EXTINGUISH THE TORCH MEETING

FIN: 439457-1-52-01 Contract No.: E8R76. Project: Reconstruct Turnpike Mainline Orange County, MP 269.4-273.3 Contractor: Hubbard Construction Company Project Acceptance Date: 06/30/2020 County: Orange

LESSONS LEARNED

SUMMARY REPORT

1) Plan Scale and Legends – Indicating Pavement Construction:

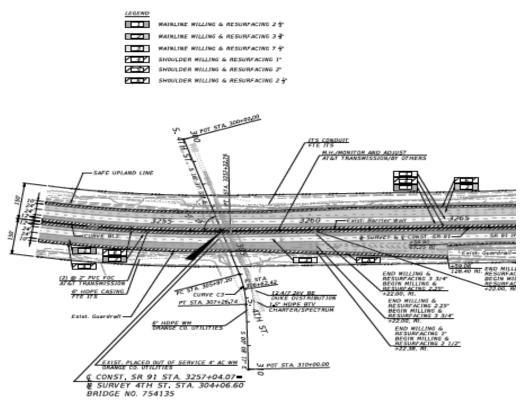
ISSUE SUMMARY: There is substantial information on each page, so when the scale is small, the Plan Views are more difficult to read. The legends are very helpful, but with just the variance of shading it is difficult to determine the limit of each area. The Contractor made various errors in milling and placement which had to be corrected at their cost.

RESOLUTION: The CEI reviewed areas to determine if placement was incorrect due to the Plans or the Contractor's misreading of the Plans and requested the Contractor to make corrections.

RECOMMENDATION: Recommend providing a more definitive set of Plans for resurfacing/ reconstruction of the roadway by providing more distinctive legends and delineation of milling and resurfacing areas, especially with the number of varying depths of resurfacing. The Contractor will be more likely to mill and resurface without having to go back and make corrections.

2) Drop-off Mitigation – Driver Expectation:

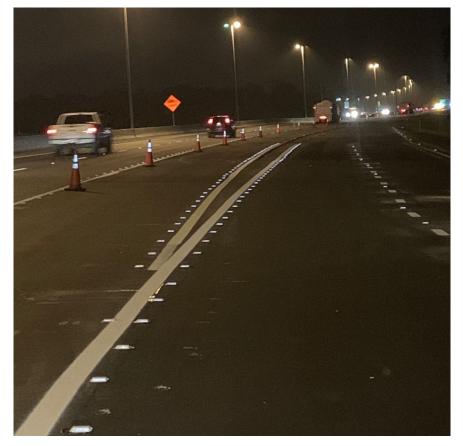
ISSUE SUMMARY: The roadway on this project consisted of four lanes in each direction. Without shifting traffic, resurfacing the second lane would have placed workers directly next to the third lane, requiring three lanes to be closed. Due to heavy traffic, a triple-lane closure would have significantly shortened the available time to work. Therefore, at certain points in the project, the original TCP required the lanes to be shifted onto the shoulder to allow the contractor to resurface the second lane, maintain two open lanes, and provide workers with a safe distance between the work and the open lanes of traffic. Unfortunately, the resurfacing of this project required a drop-off between resurfaced lanes and the lanes that had not yet been resurfaced. Prior to shifting traffic, the drop-off was at the lane line; however, once the traffic shift was installed, the drop-off was between the vehicles tires, requiring the drivers to drive with one side of the vehicle at a different elevation than the other side of the vehicle. Although no accidents were attributed to this condition, complaints came in from various travelers on the roadway that the ride was uncomfortable and the condition was perceived to be unsafe.

RESOLUTION: Midway through the project, the traffic shift was changed so the drop-off remained at the lane lines. In some areas, this required a triple-lane closure to perform the resurfacing. In other areas, a triple-lane closure was impractical. In those areas, to allow two lanes to remain open while the middle lane was being resurfaced (as was the goal of the original TCP), additional striping was placed so the lanes on either side of the drop-off were at least 4' apart, creating a buffer between the lanes. When the lane on one side of the drop-off was closed for resurfacing, the lane on the other side of the drop-off could be left open, affording workers at least a 4' buffer from the active traffic. During the day when all the lanes were open, the buffer formed a "no drive" area, which could be crossed for lane changes but better assured drivers that they would not have to straddle the drop-off. *Note: This was implemented as a field change.*

RECOMMENDATION: During design, provide traffic shifts, including the use of buffer zones if needed, to assure the drop-offs are contained at the lane lines and provide for smooth transitions when having to travel across the areas with the drop-offs to the next area where work has not been performed.

5) Identification of cross-slope changes in the shoulder

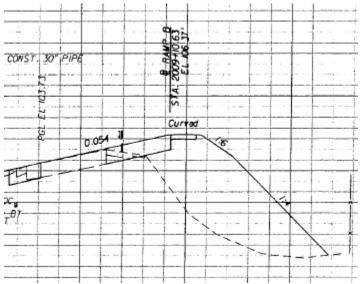
ISSUE SUMMARY: After resurfacing of the shoulder, water was being retained within the shoulder area, which was not an existing condition. When temporary pavement is being placed to shift traffic on to the shoulder, the existing shoulder slope can get lost especially for when the shoulder needs to break. The contractor continued paving through this section at the same slope as the shoulder coming into where the break needed to occur.

RESOLUTION: The CEI had procured the Final As-built Plans of the previous construction project and found there was break in the existing shoulder. The as-built plans show this as "Curved". (See below). The contractor was directed to mill and resurface the shoulder to match the existing condition.

RECOMMENDATION: Provide Station and grades for existing shoulder breaks in the Plans.
